Product / Process Change Notification (PCN)

PCN Number: PCN_UtLAN_20240807

Affected Order Codes: 749014xxx, 749424xxx

2. Packaging change:

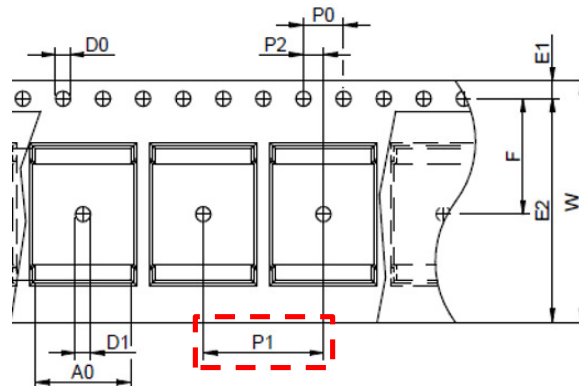
Affected order codes: 749014011, 7490140110, 7490140112, 749014012, 749024010

Before Change	After Change
SPQ:	250 pcs	200 pcs
Carton Quantity:	750 pcs	1200 pcs
Carton Length:	365 mm	370 mm
Carton Width:	342 mm	400 mm
Carton Depth:	230 mm	370 mm

5. Datasheet correction

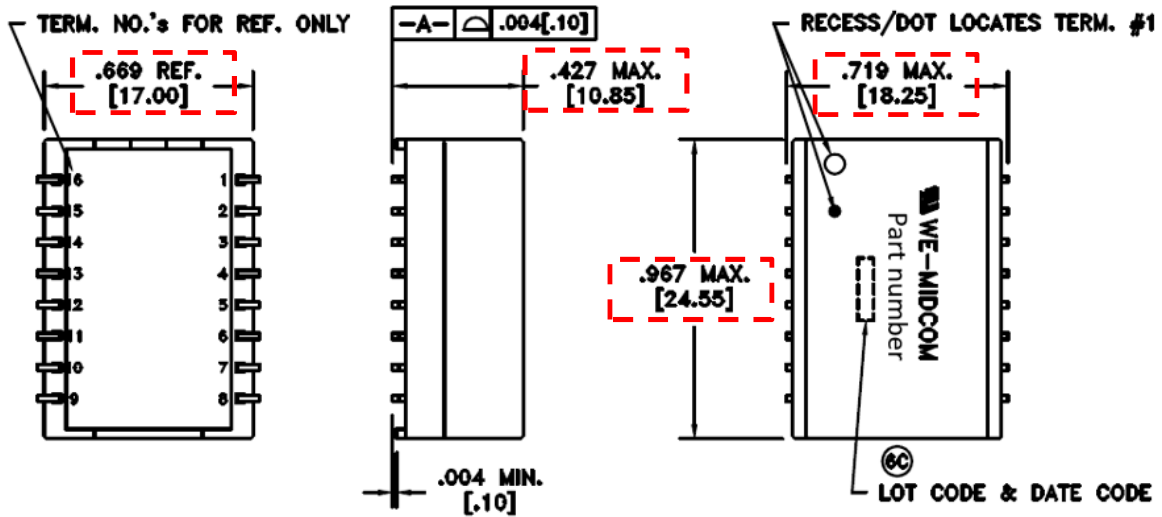
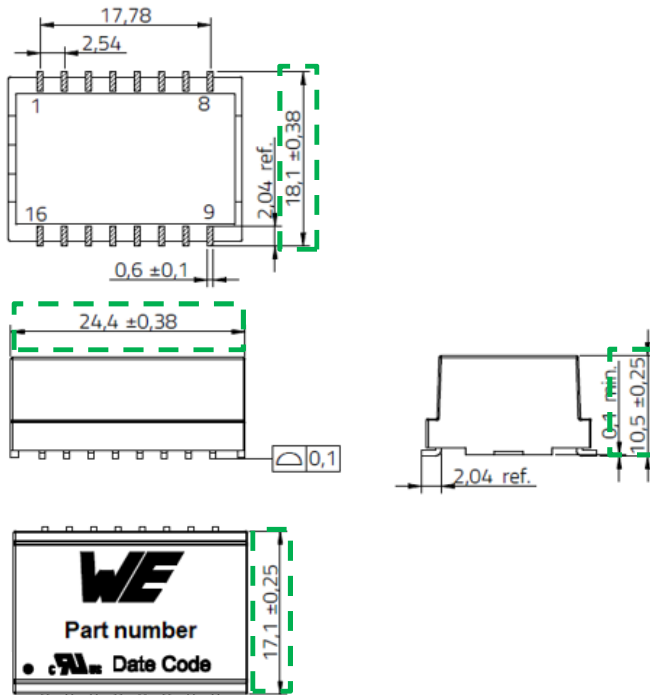
Affected order codes: 749014011, 7490140110, 7490140112, 749014012, 749024010

Before change:

After change:

5. Datasheet correction

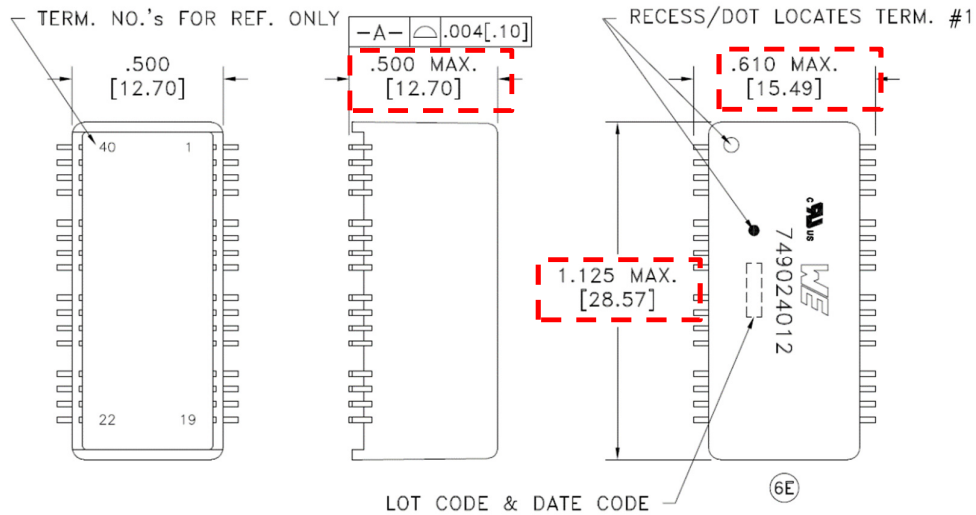
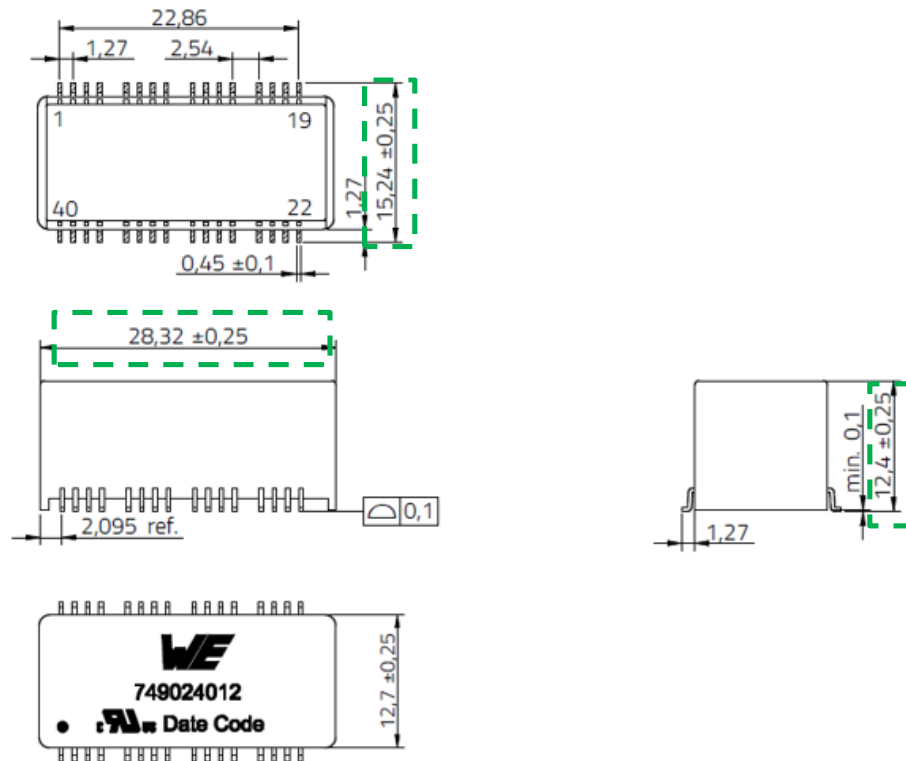
Affected order code: 749024012

Before change:

After change
